TO: District of Columbia Zoning Commission
FROM: Stephen Cochran, Development Review Specialist
JL for Jennifer Steingasser, Deputy Director, Development Review & Historic Preservation
DATE: November 10, 2020
SUBJECT: Supplemental Report on Zoning Commission Case No. 20 – 14 - Design Review for Development Proposal for 5 M Street, S.W.

Figure 1. Component Sections of Single Proposed Building

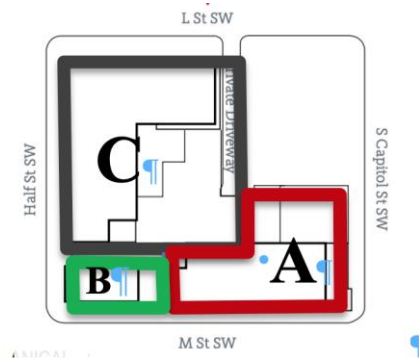
The areas labelled “A” and “B” would have ground floor retail along South Capitol Street and M Street with apartments above. “B” would also provide the meaningful connection between “A” and “C”. The area labelled “C” would have only residential uses. At this time the applicant intends to construct all modules at the same time but has also indicated it may decide to construct the “A” and “B” modules in a first phase and the “C” module in a second stage.

The “A” and “C” sections would have 13 floors in 130 feet and would be connected by the 8-story, approximately 80-foot high section “C”. Each section would have a different façade treatment with some elements common among all three.

The height reduction of the "B" section also would help the overall building emulate some of the changes in height among buildings facing M Street, S.W. as would the voluntary ½: 1 setback on M Street above 110 feet. The design of the "C" section would be more in keeping with its surroundings if the setback at the corner of L and Half Streets were continued all the way down Half Street.
